DRAWING NO. D206-667-141	TITLE CROSSTUBE ASS'Y (206B HIGH FWD)	REV. C	DART AEROSPACE LTD ENGINEERING ORDER		D.E.O. NO. D206-667-141-C-1	SHEET NO. SHEET 1 OF 1	SCALE NTS
DRAWN <i>q</i>	CHECKED <i>ASS</i>	MFG. APPR. <i>MD</i>	APPROVED <i>MD</i>		DE APPR. <i>MD</i>		
DATE 11.07.15	DATE 11.07.20	DATE 11.07.21	DATE 11/07/21		DATE 11.07.21

REPLACE MAGNOBOND WITH PROSEAL.

DRAWING NO. D206-667-141	TITLE CROSSTUBE ASS'Y (206B HIGH FWD)	REV. C	DART AEROSPACE LTD ENGINEERING ORDER		D.E.O. NO. D206-667-141-C-2	SHEET NO. SHEET 1 OF 1	SCALE NTS
DRAWN AJ5	CHECKED	MFG. APPR.	APPROVED		DE APPR.		
DATE 12.08.02	DATE 12.08.02	DATE 12.08.02	DATE 12.08.02		DATE 12.08.02	DATE 12.08.02

ADD ELECTRICAL GROUNDING STRAP

DETAIL P
BONDING STRAP INSTALLATION 2 PL

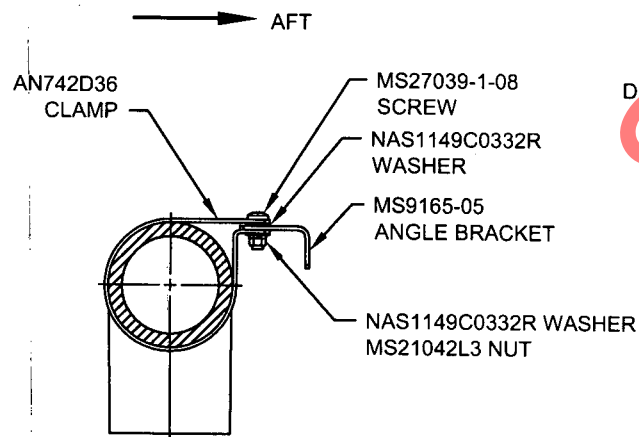
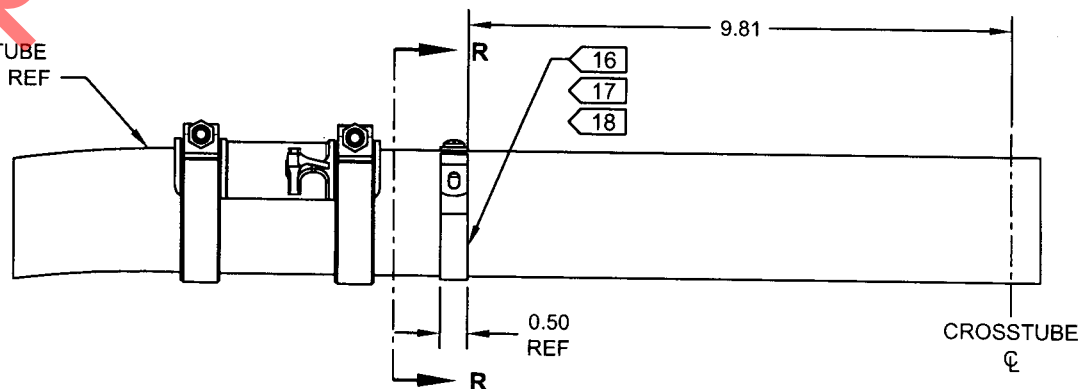
ITEM	QTY -141	PART NUMBER	DESCRIPTION
1	X	D206-667-141	CROSSTUBE ASSEMBLY (206B HIGH FWD)
10	2	AN742D36	CLAMP
11	2	MS9165-05	ANGLE BRACKET
12	2	MS21042L3	NUT (OR MS21042-3)
13	2	MS27039-1-08	SCREW
14	4	NAS1149C0332R	WASHER (OR AN960C10L)

- 16) MASK AREA UNDER CLAMP PRIOR TO PAINTING
- 17) SEAL EDGES WHERE AN742D36 CLAMP MEETS WITH THE CROSSTUBE USING SIKAFLEX-241/-291 OR MIL-S-8802 CLASS B2 OR PROSEAL 890 SEALANT
- 18) PERFORM RESISTANCE CHECK TO ENSURE MAX RESISTANCE IS 10 MILLIOHMS
